Braham, Peter*RZ 2001-MV-025*

From: Braham, Peter
Sent: Friday, June 16, 2006 1:24 PM
To: 'Nelson Kirchner'
Cc: Simms, Michael L.; Johnson, Leslie
Subject: RE: Laurel Hill LB D-2 Lot 105 (Previous Lot 34)
Attachments: LH D2 Lot 105 Exhibit Model (1).pdf

In response to your e-mail and after coordinating with Michael Simms and Barbara Byron, the following is the determination with regard to the issues associated with 8928 Rhododendron Circle.

#8928
 RHODODENDRON
 CIRCLE
 TAX MAP # 106-4

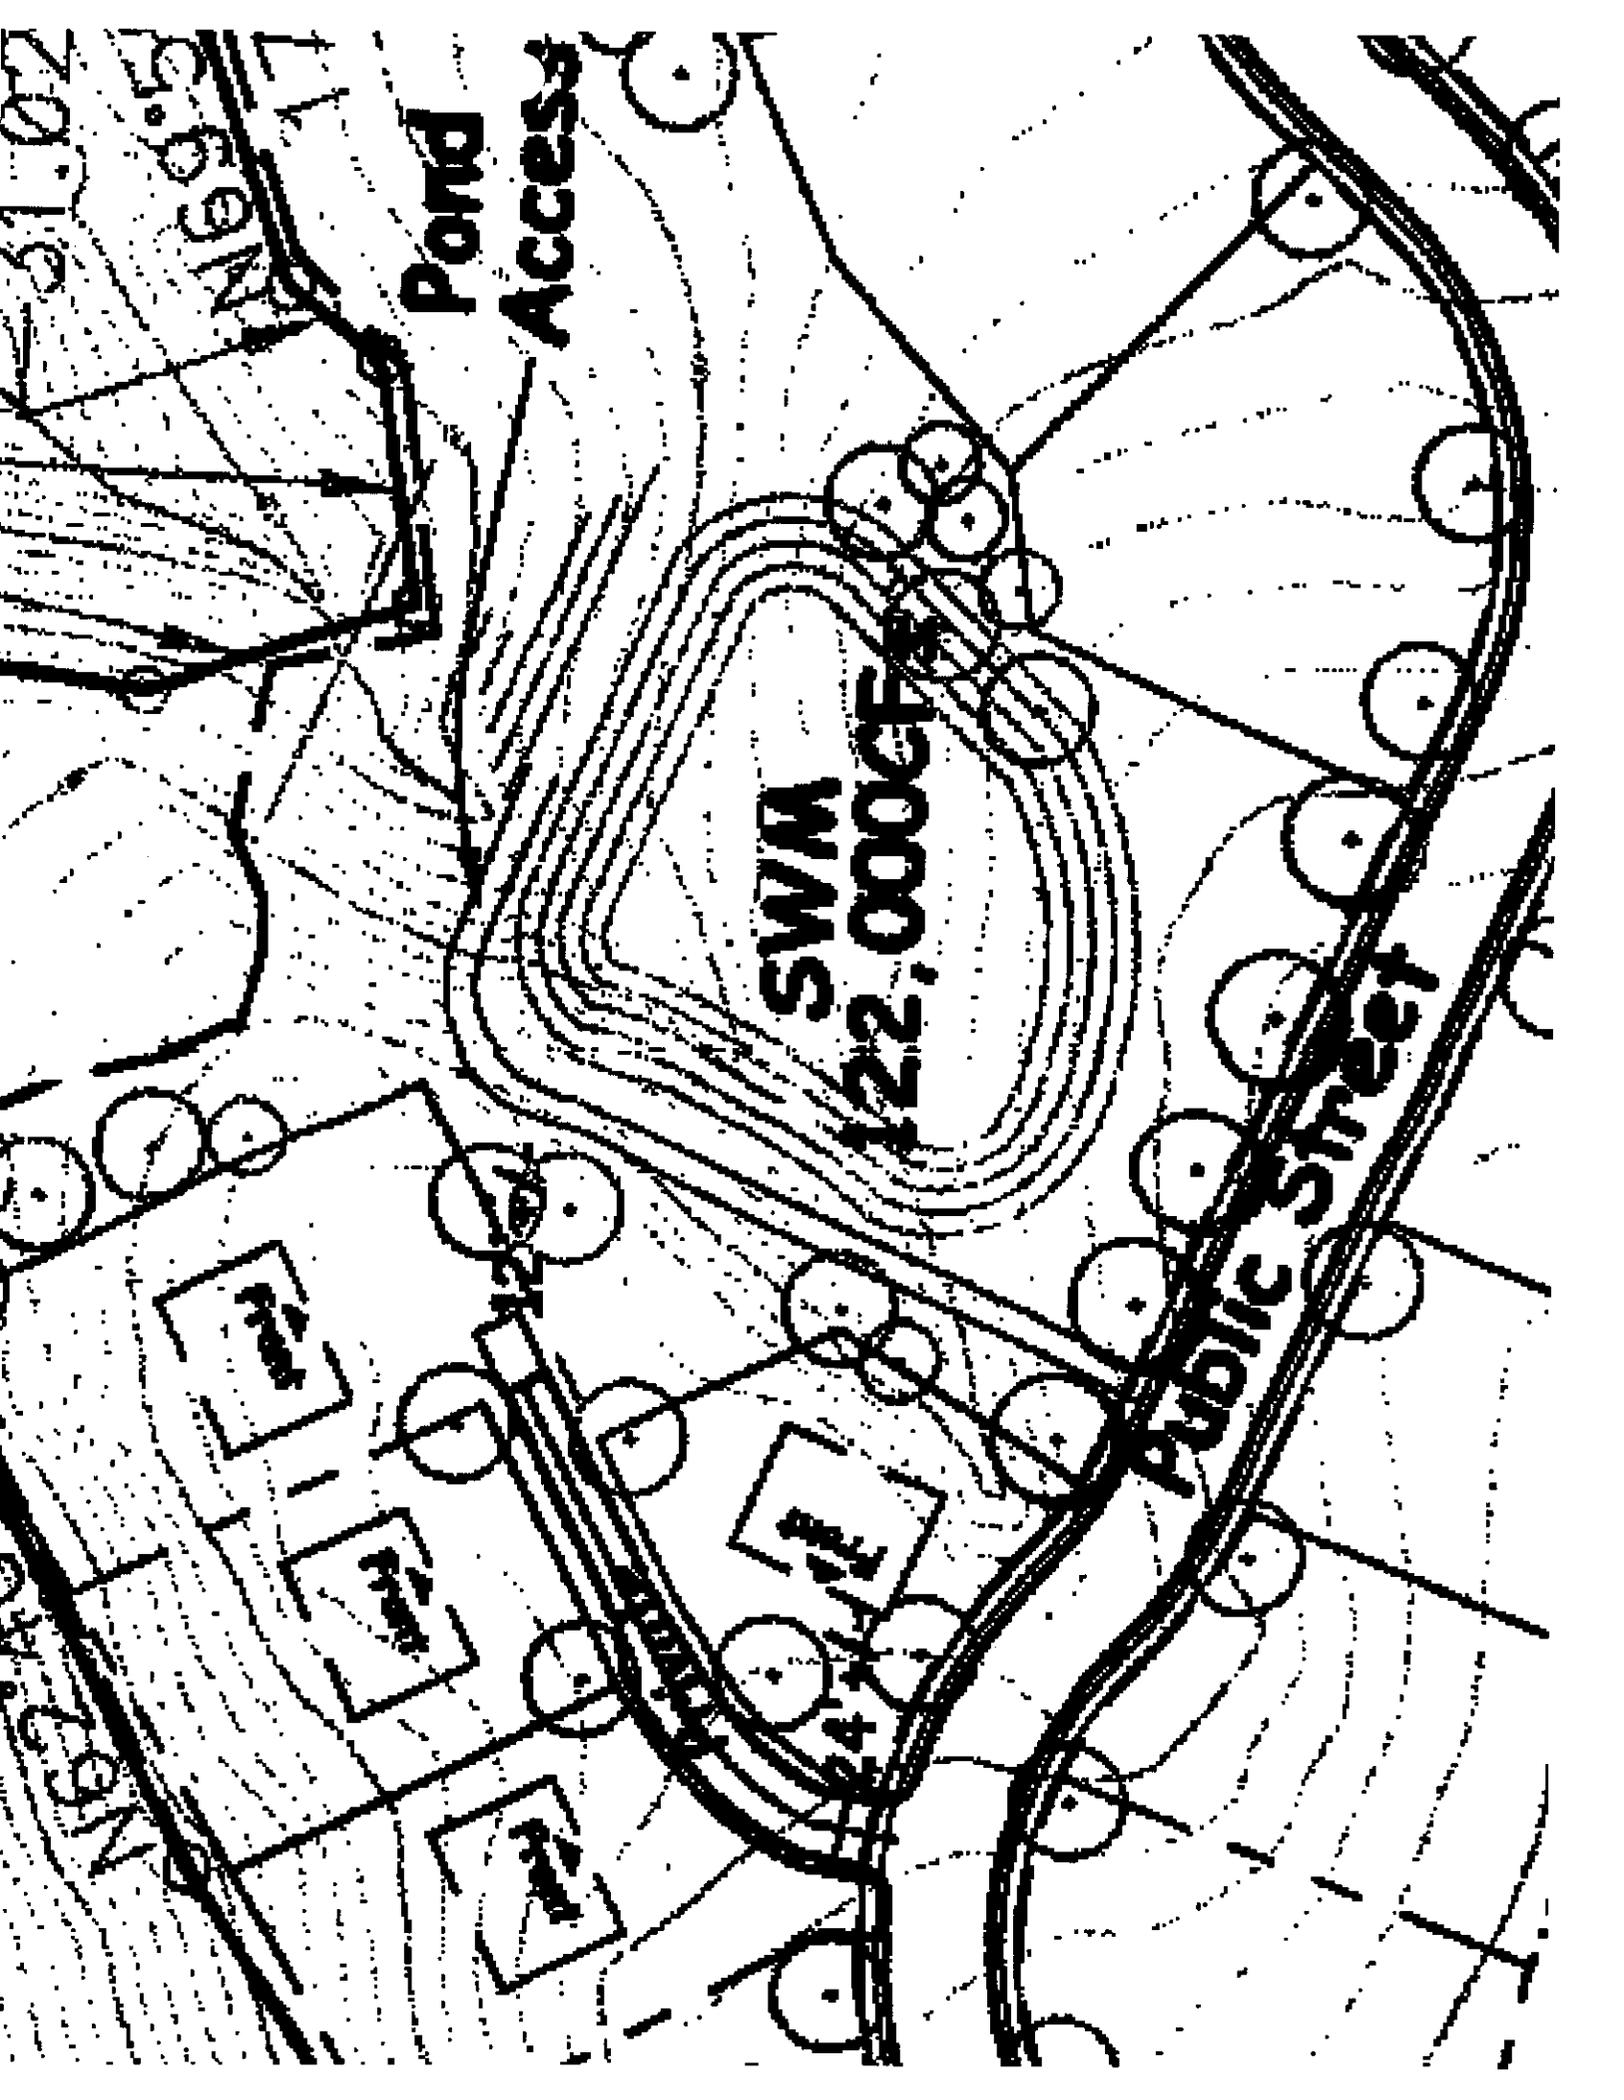
The property must comply with the yard dimensions established for this type of unit as shown on the typical lot layouts included on Sheet 14 of the proffered CDP/FDP while applying those yard dimensions in the manner prescribed by the Zoning Ordinance. In addition, the house must face in the direction shown on the proffered CDP/FDP, i.e. towards the pipestem driveway.

Accordingly, given that the lot is shown on the proffered CDP/FDP to face onto the the pipestem driveway and onto the public street, it must be setback 20 feet from the public street and 25 feet from the pipestem driveway. Since the definitions of various types of yards contained in Article 20 of the Zoning Ordinance specifies that the yard opposite the shorter of two yards of a corner lot, the yard behind the house and opposite the pipestem driveway is a side yard (which must be 7 feet per the proffered typical) and the yard furthest from the public street is a rear yard and must be 20 feet per the proffered typical. Therefore, the yard designations on the attachment to your email are incorrect and must be changed. The yard labeled as the rear yard on the attachment is defined as a side yard; and the yard labeled as a side yard is defined as a rear yard. Further, the seven foot side yard shown on the attachment must be increased to twenty feet.

It should be noted that it is recognized that these yard designations, while consistent with the Zoning Ordinance definitions, are not how a layperson would intuitively apply the terms rear yard and side yard. Therefore, it is requested that the house location plat be clearly marked to identify which yard is which and to state that the limitations regarding accessory structures and permitted extensions into yards (including decks) are different with regard to rear and side yards.

To address this situation, this office would be willing to consider a proffer interpretation to move the property line that is parallel to the public street away from the house to meet the 20 foot rear yard requirement.
